Programmatic
Environmental Impact Statement
related to decontamination and disposal of radioactive wastes resulting from March 28, 1979 accident Three Mile Island Nuclear Station, Unit 2

Docket No. 50–320

Final Supplement Dealing with
Post-Defueling Monitored Storage
and Subsequent Cleanup

U.S. Nuclear Regulatory Commission

FIGURE 2.4. Map of the General Area Exposure Rates 4 to 7 Feet (1.2 to 2.1 Meters) Above the 282-Foot Elevation During May 1989, in R/h for Gamma Radiation

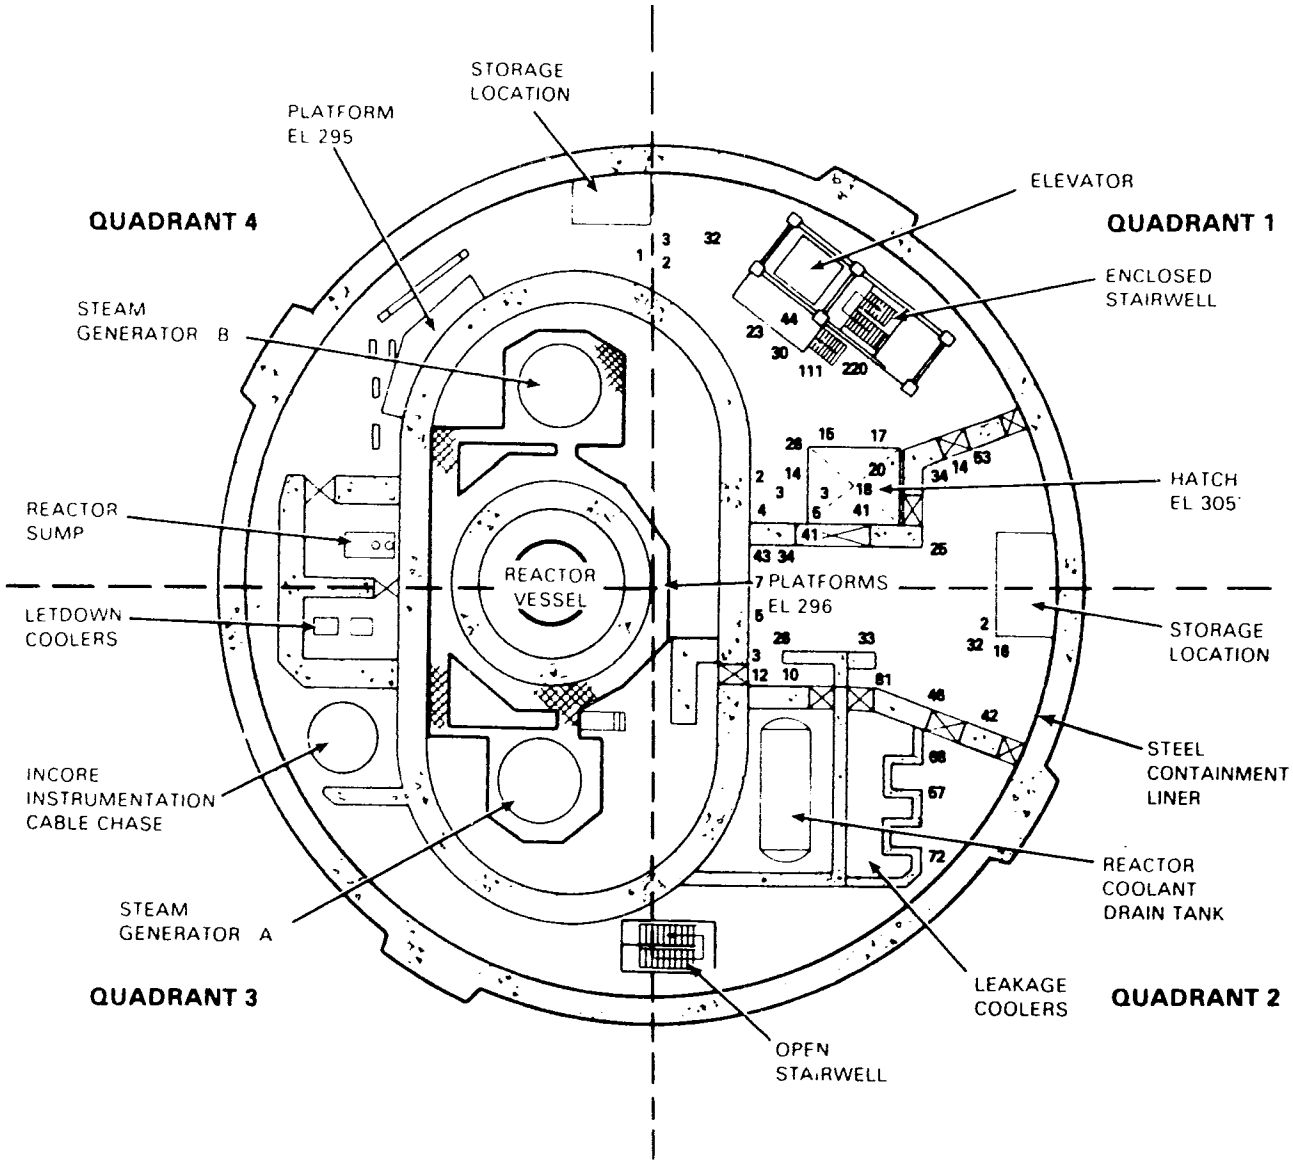
2.1.1 Page 2.12/Figure 2.7 - The data presented in this figure should be clarified. The radiation exposure rates are not general area exposure rates but rather are exposure rates obtained by use of a shielded directional probe. Most of the data is derived from contact readings. Even the general area readings are highly directional and do not give an accurate representation of actual general area exposure rates. Thus, the actual general area exposure rates, taken with a non-directional probe, would be lower than the contact exposures rates but higher than the general area exposure rates identified on this figure.

A map of the radiation exposure rates in the basement during May 1989 is shown in Figure 2.4. Most of the data in this figure were obtained from contact readings (all measurements were made with a shielded directional probe). The radiation levels in the basement vary somewhat with elevation. This map represents conditions 4 to 7 feet (1.2 to 2.1 meters) above the floor of the basement. General area radiation exposure rates taken with a nondirectional probe would be lower than the contact exposure rates, but higher than the general area exposure rates identified in Figure 2.4. The highest measured radiation exposure rates (400 R/h to 1100 R/h before decontamination) in the reactor building basement were in the vicinity of the elevator shaft and enclosed stairwell. These structures, which are made of hollow concrete blocks, became saturated with the accident-generated water and absorbed radionuclides from the water. Analyses of core samples of the concrete block indicate that the contamination (primarily cesium-137) has completely penetrated the concrete block. Analyses of core samples from the concrete walls indicate that approximately 90 percent of the radioactivity (primarily cesium-137) in the concrete walls and the D-ring walls is within the first 1/8 inch (0.3 centimeter) to 1/4 inch (0.6 centimeter) of concrete.
